SUBJECT: Transmittal of Responses to AP1000 DSER Open Items

AP1000 Design Certification Review
Draft Safety Evaluation Report Open Item Non-Proprietary Responses

DSER Open Item Number: 5.2.3-3 Revision 1

Figure 1 – Axial (top) and hoop (bottom) stresses on the DVI nozzle arising from an accident event in which the nozzle temperature is reduced from 550°F to 50°F in 30 seconds due to failure of the CMT isolation system.

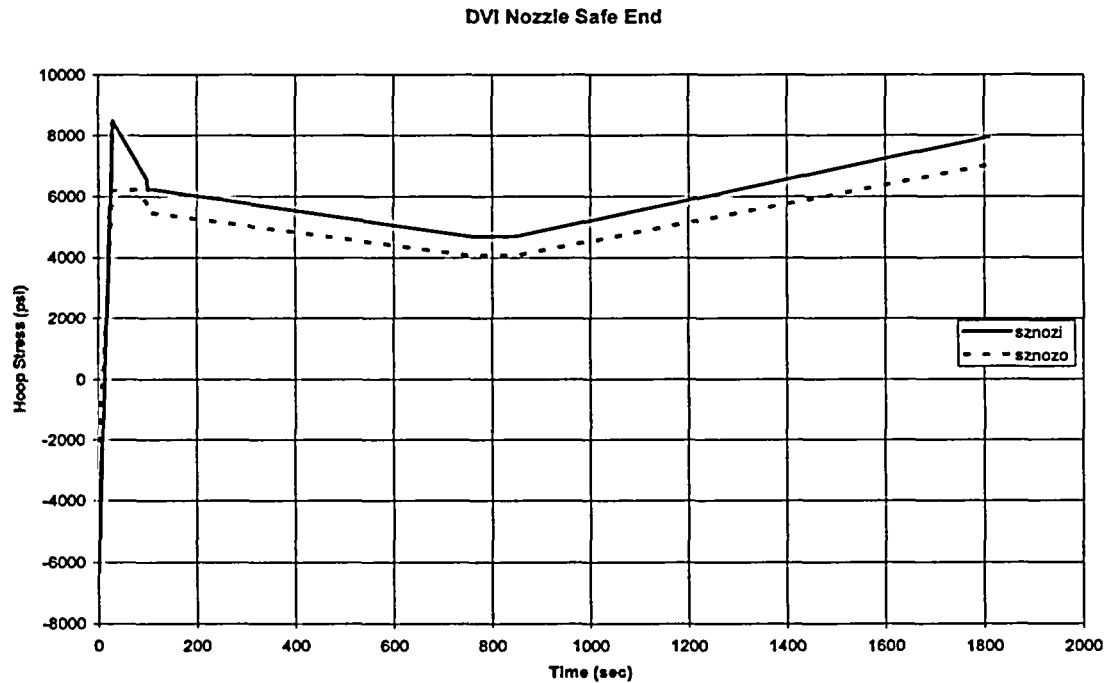
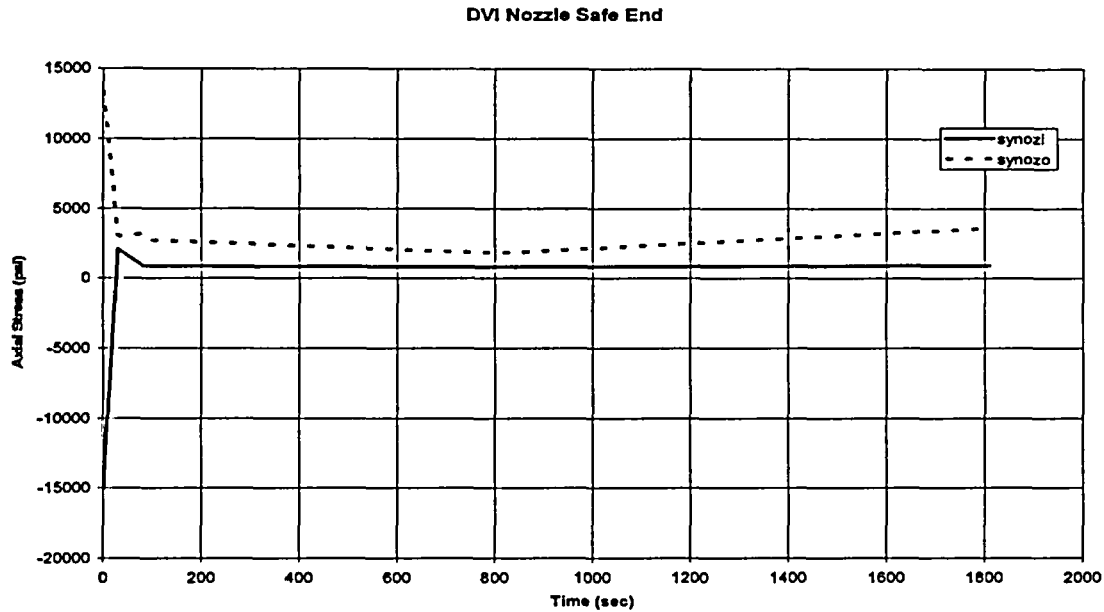
- d. Assume a small but credible ID surface breaking flaw in the bi-metallic welds identified in parts b. and c. above. Evaluate what conditions and effects the flaws would see as a result of the limiting transient(s) (i.e., hydrogen concentration, final temperature, loading rate, and failure potential).

the CMT cools the safe-end weld from 550°F to 50°F in 30 seconds. This leads to a rapid spike in the stresses, both on the inside and on the outside of the nozzle. Figure 1 shows the results of the temperature and pressure transients on the axial (top plot) and hoop (bottom plot) stresses. The solid curves are of interest, since they are the stresses acting at the inside, wetted surface.

The ID hoop stresses peak at about 9000 psi in 30 seconds, after which the stresses begin to decrease and then slowly rise to approximately 8000 psi at 30 minutes (1800 seconds) when the safety valve pressure is reached. The stresses would not increase further even if the operators took no remedial action at thirty minutes because the safety valve setpoint has been reached. The normal operating stresses at this location due to pressure and thermal loads are 10,000 psi (hoop). Thus, the maximum stresses experienced by the DVI nozzle welds will be on the order of 19,000 psi. The yield strength of the Alloy 52 weld metal can be conservatively estimated as 50,000 psi. Hence, it is concluded that the stresses do not approach the level where LTCP might occur, and **Condition 4 is not satisfied**.

Figure 2

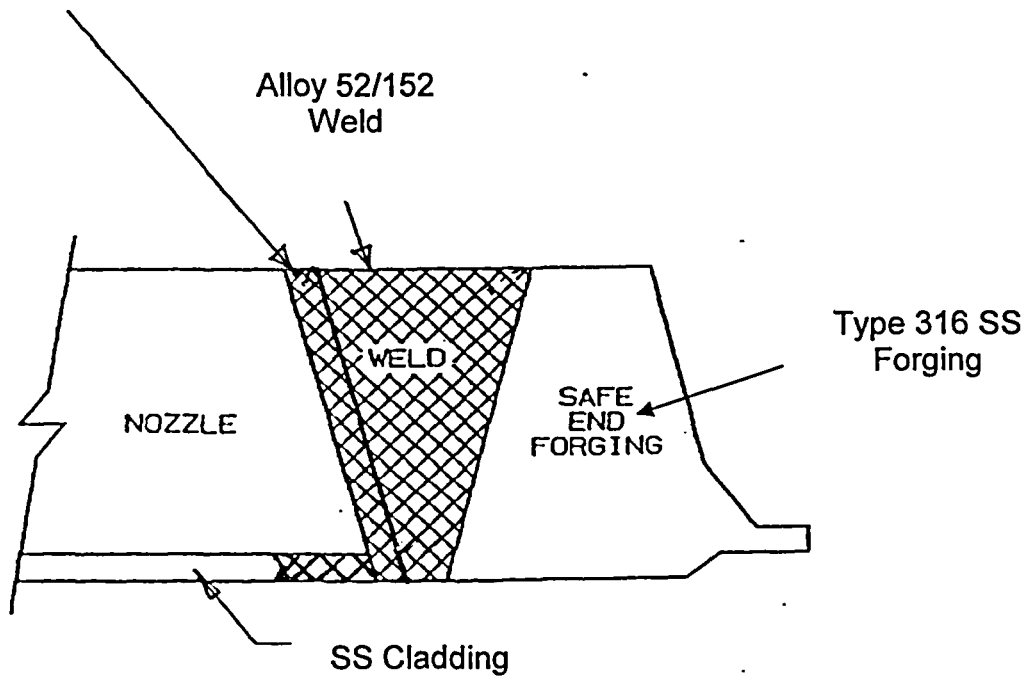
- c. Provide a schematic drawing of welds at these locations. For example, describe whether these welds would consist of Alloy 52 material through the entire wall or would consist of Alloy 52 in contact with the reactor coolant and Alloy 82 for the remainder of the wall thickness.

- c) Figure 2 provides a sketch of a typical nozzle safe-end butt weld. These welds are composed entirely of Alloy 52 (root and subsequent few passes) and Alloy 152 (later passes).

Figure 21.5-1.12 ADS-4 Liquid Discharge Comparison

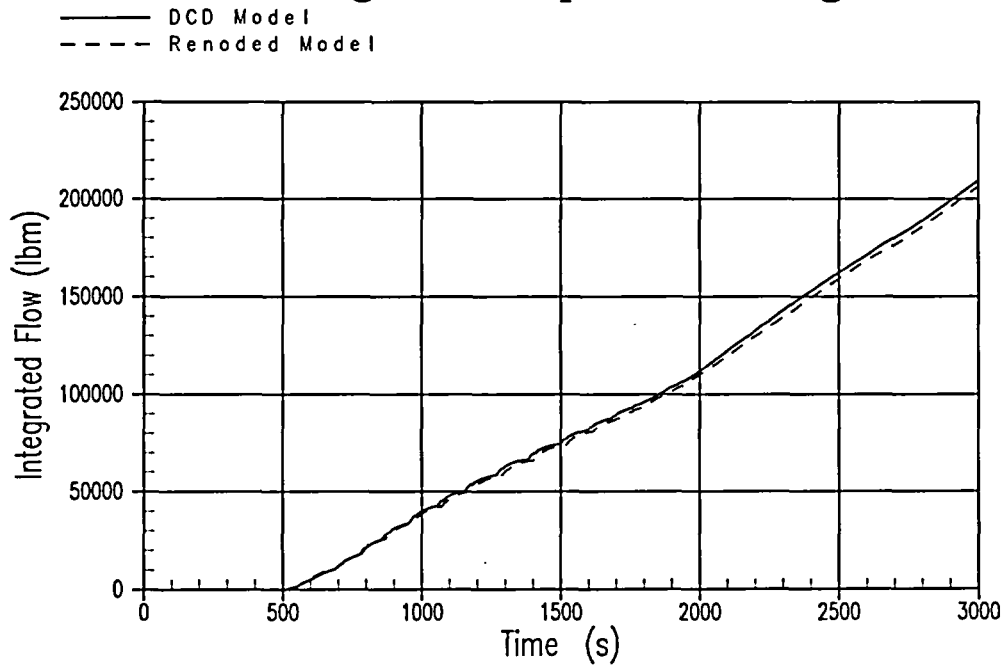
For the comparison of the integrated liquid discharge through ADS-4 between the base DCD case and the revised nodding model, Figure 21.5-1.12 on DSER OI 21.5-1P Page 11 has an inconsistency in that the heading states "ADS-4 Liquid Discharge Comparison" whereas the actual figure is for ADS-4 integrated vapor discharge.

Correct Figure F-12 (i.e., Figure 21.5-1.12) for ADS-4 Liquid Discharge Comparison.

Figure 21.2.1-12 was intended to be a plot of ADS-4 Liquid Discharge Comparison. However the figure that was included was ADS-4 integrated vapor discharge as the Item states. The attached figure is the corrected Figure 21.5-1.12 that shows ADS-4 Liquid Discharge Comparison.

Figure 21.5-1.14 Downcomer Pressure Comparison

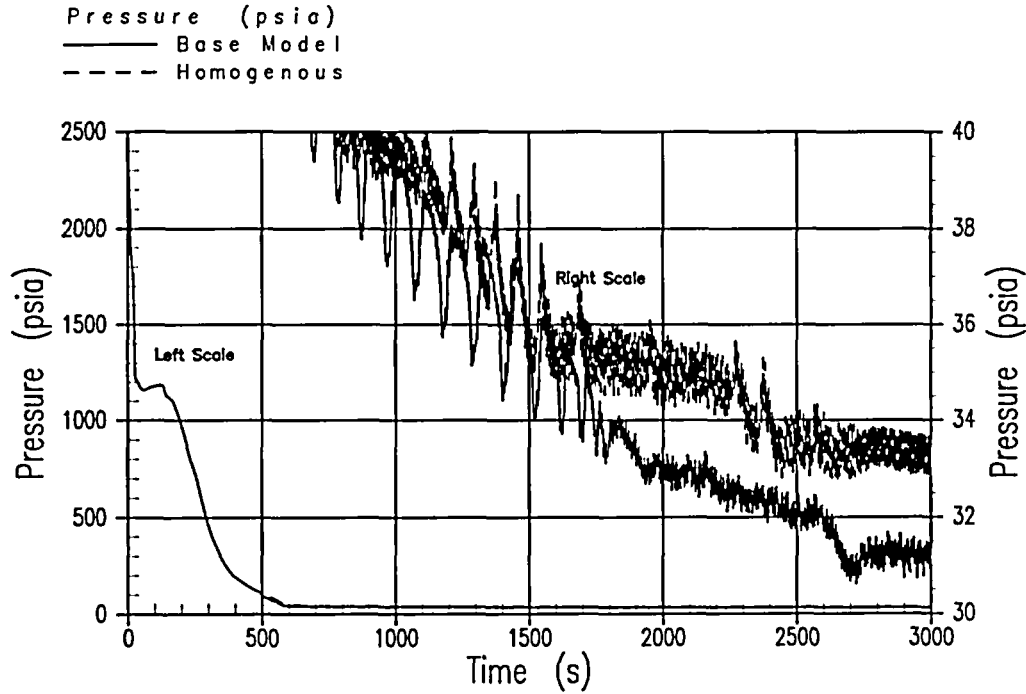
Correct text and Figure F-14 (i.e., Figure 21.5-1.14) to show Downcomer Pressure Comparison.

The text on DSER OI 21.5-1P Page 3 states that Figure 21.5-1.14 presents a comparison of the upper downcomer pressure between the base case and the sensitivity case, but the actual figure is for pressurizer pressure (except for the heading). The text also states that the pressurizer mixture level response (Figure 21.5-1.25) reflects the change in pressure response (Figure 21.5-1.14) observed in the model.

Figure 21.5-1.14 was intended to show the upper downcomer pressure between the base case and the sensitivity case, but the actual figure is incorrect as stated in Item 17 above. The attached figure provides the corrected Figure 21.5-1.14. The plot of Pressurizer pressure is also provided as 21.5-1.26 and the text should refer to this figure for pressurizer pressure. No update to the previous response is intended.
